# Environmental Resources Management, Inc.

RE: Textron/ERM Presentation to PADER/EPA, 25 April 1991

## SUMMARY OF ERM-TEXTRON PRESENTATION 25 APRIL 1991

**Subject: Need for Additional Off-Site Ground Water Recovery at  
Textron Lycoming, Williamsport**

Figure 1  
WMWA Well #9

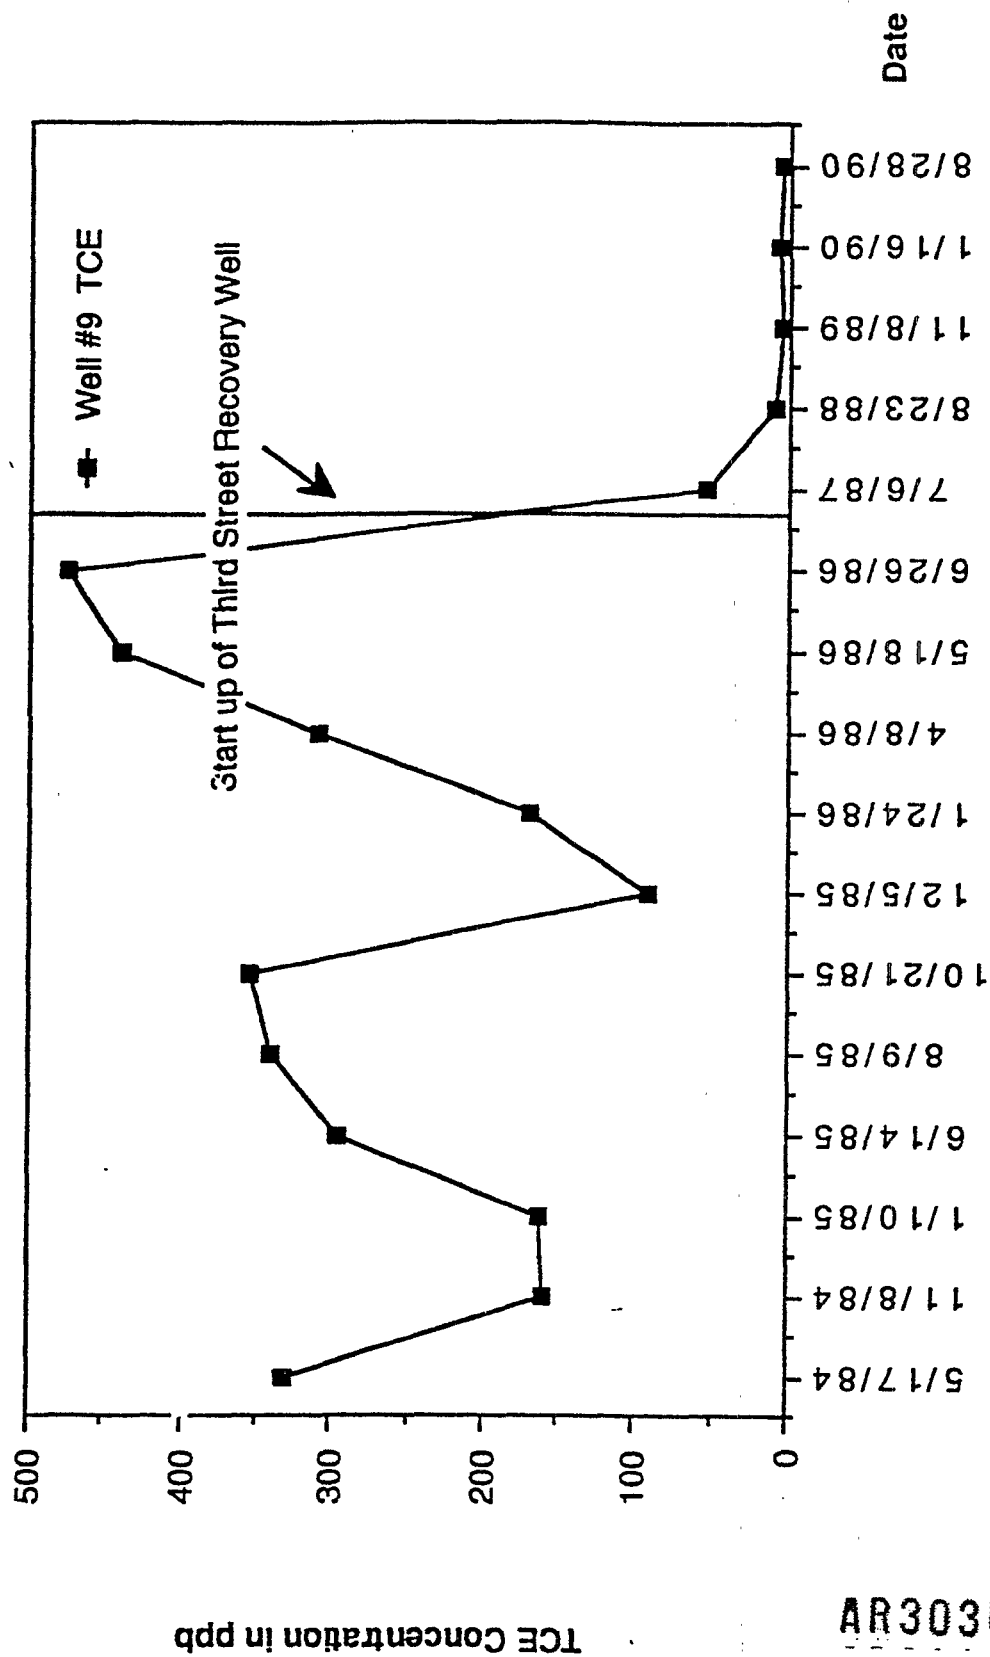
- The present off-site ground water recovery system has significantly reduced the concentrations in all of the WMWA production wells, demonstrating the effectiveness of the Third Street well as a blocking/recovery well (see Figure 1, representing VOC trends in WMWA Well No. 9). As shown in the appendices to the RI, on-site and off-site monitoring wells and the WMWA wells show decreases in contaminant concentrations since installation of the existing recovery systems.

# Figure 2

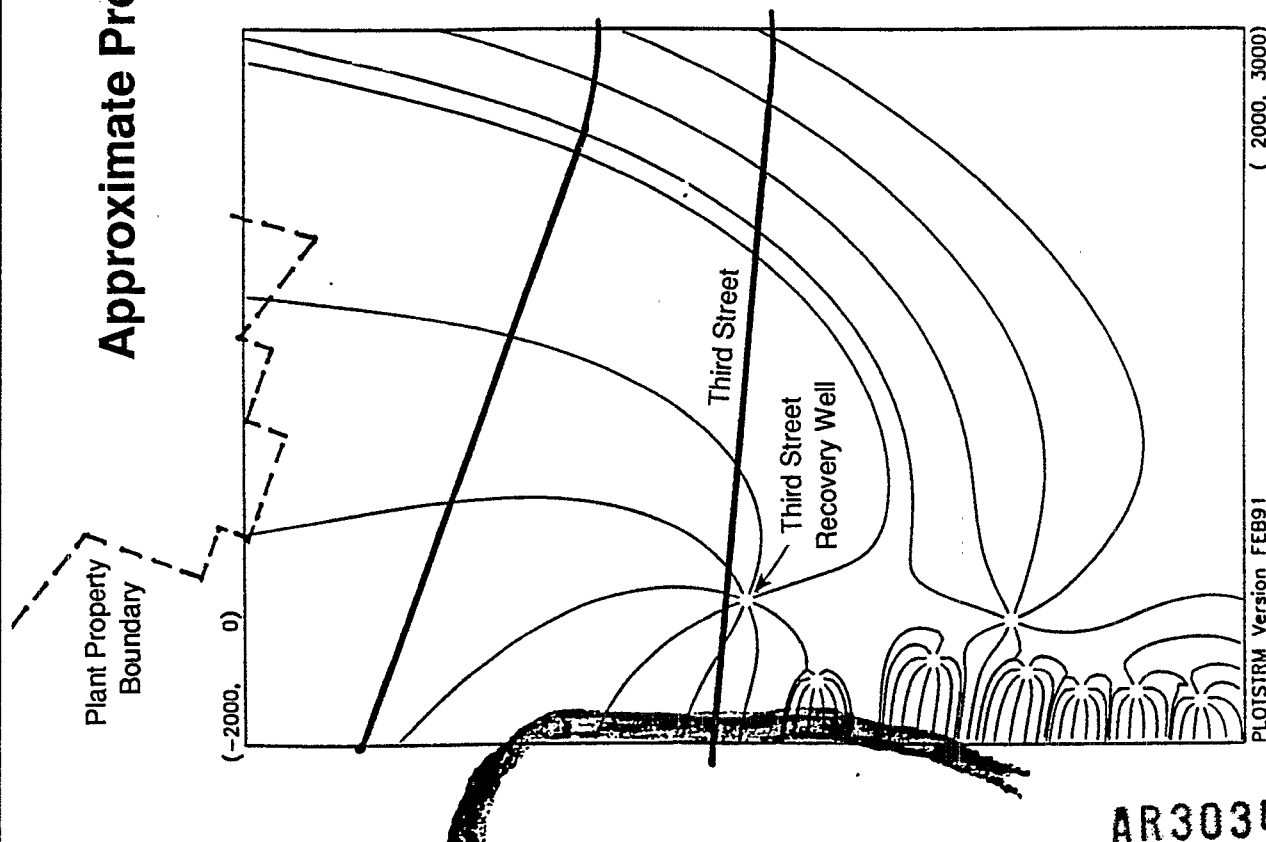
- The overburden plume is being captured by the pumping of the Third Street Recovery Well. This was demonstrated by a two-dimensional streamline model completed by ERM. This model uses the same basic Theis assumptions as the DREAMS or RESSQ models. The model was used to demonstrate the capture area of the Third Street recovery well when this well is pumping at 500 gpm. In addition, each of the WMWA production wells was simulated in the model to pump 100 gpm, and the recharge boundary of Lycoming Creek was simulated using the image well theory to present a worst-case scenario. Figure 2 presents the modeled capture zone of the Third Street recovery well. The model demonstrated that pumping at the rate of 500 gpm, with all of the WMWA wells operating, the Third Street Recovery Well effectively captures the entire off-site overburden contaminant plume.
